TfNSW reference: STH24/00111/004

Warrawong Plaza State Assessed Planning Proposal – LOT 1 DP217579 – 43-65 Cowper Street WARRAWONG

DE-2023/95
31 July 2024

SUBMISSION: STATE ASSESSED PLANNING PROPOSAL – COWPER STREET, WARRAWONG

Figure 1: Height of Building and the Centres Hierarchy

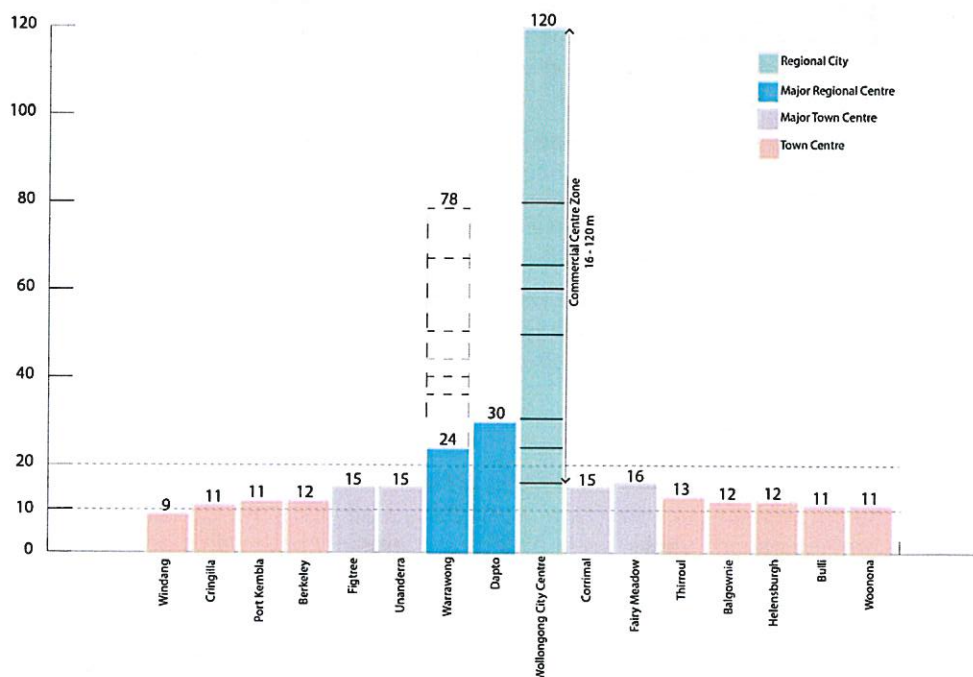
There are no changes to the existing FSR of 2.5:1 proposed. The available FSR does not facilitate a right to floorspace that justifies an amendment to the HOB development standard to the extent proposed or at all.

HOB controls across Wollongong centres correspond to their place in the Centres Hierarchy, being responsive to both the role and function of the Centres (Retail/Office/Residential typologies and scale), as well as the surrounding context. The graph below (figure 1) shows the current upper HOB limits across each Town, Major Town, Major Regional and Regional City Centre. For context in understanding the HOB limits proposed for Warrawong Plaza, the range of heights permitted in the City Centre of Wollongong are shown as black lines. Corrimal Train Station (outside but in the vicinity of the Corrimal Major Town) is identified as a Transport Orientated Site, which provides an alternative approval pathway for height up to 22m for residential flat building and 26m for shop top housing. Within the City Centre E2 Commercial Centre Zone, heights between 16m and 120m are permitted. The range of proposed heights for the Cowper Street Warrawong site are shown dashed above the existing permitted height of 24m. A review of the heights across Wollongong will occur over time as appropriate for each centre, but for in the current context the proposed heights are out of scale. The proposed Height limits are clearly significantly over the current settings for Major Regional Centres.
